# **Site Audit Report – Stage 1 Area Ongoing Groundwater Monitoring**

## **Clyde Western Area Remediation Project**

Viva Energy Australia Pty Ltd

29 November 2021

Figure 4 Groundwater level fluctuation and benzene trends

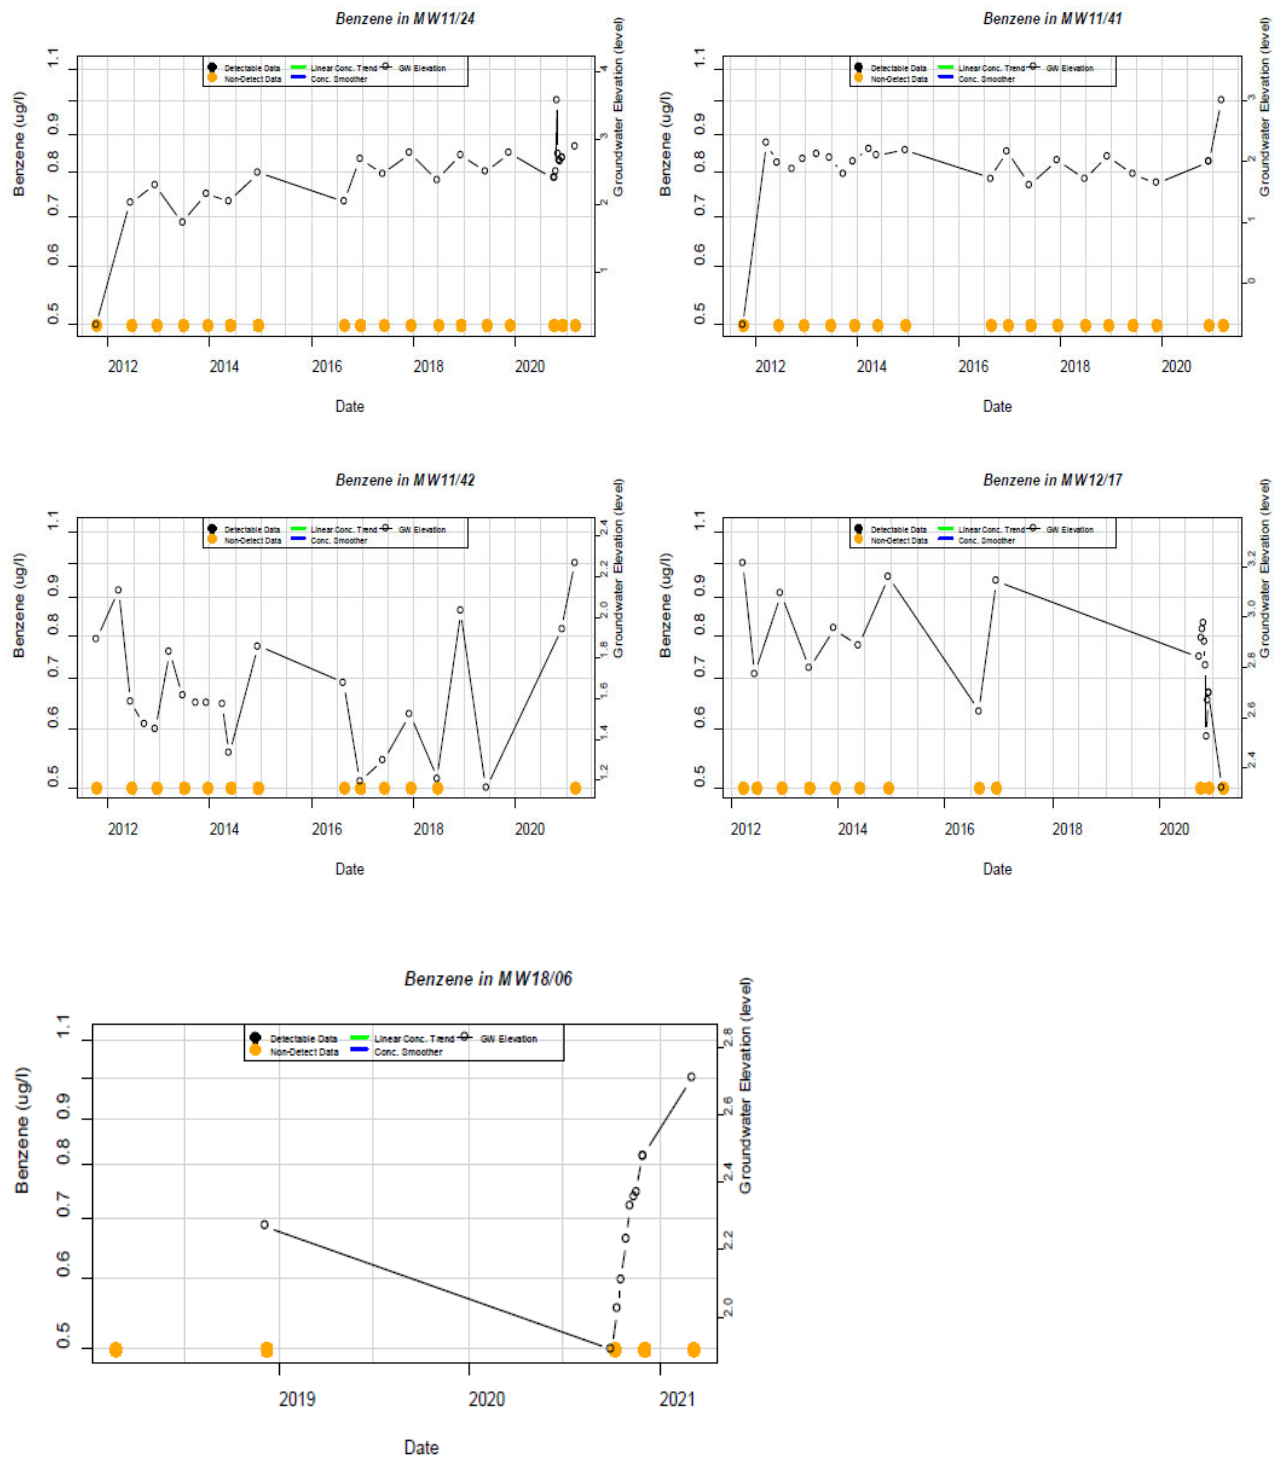
The auditor supports ERM's recommendation of cessation of groundwater monitoring. As the Stage 1 Area will remain subject to the unexpected finds protocol and relevant conditions outlined in the updated Stage 1 LTEMP, the LTEMP (that was the subject of the Stage 1 SAR and SAS issued in February 2021) was updated to remove the requirement for groundwater monitoring.

Figure 3 Groundwater level fluctuation and benzene trends (extracted from ERM, 2021c)

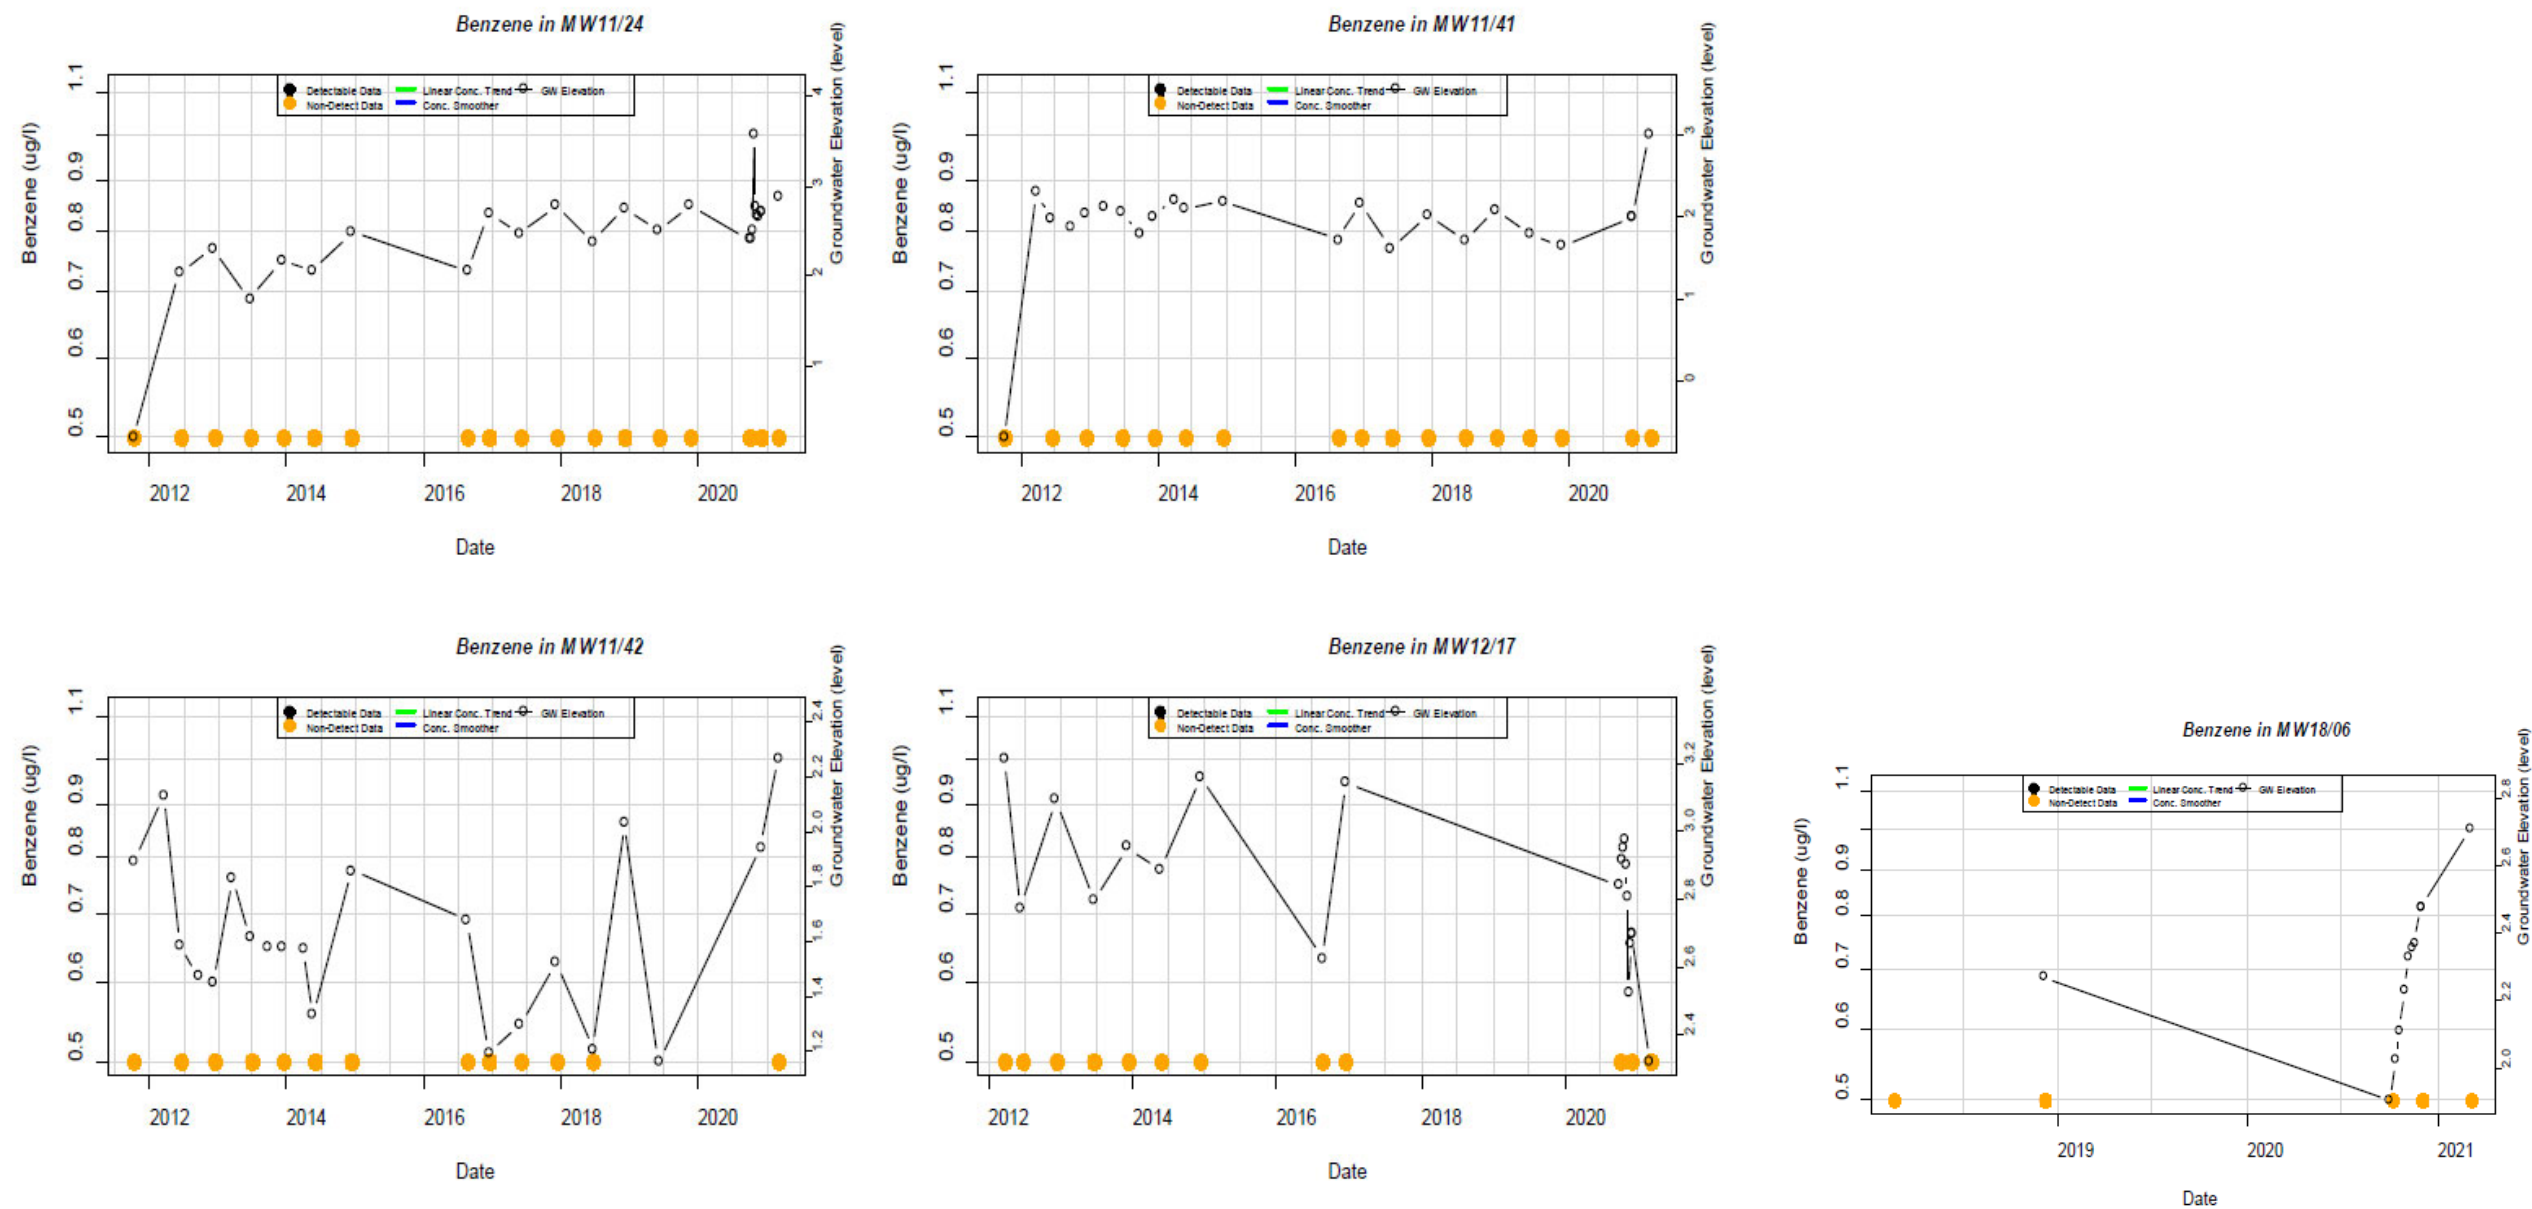
The auditor notes that the Stage 1 Area will remain subject to the unexpected finds protocol and relevant conditions outlined within the Stage 1 LTEMP. As the LTEMP will need to be updated to remove the groundwater monitoring, this update will need to be reflected in an updated SAR/SAS.
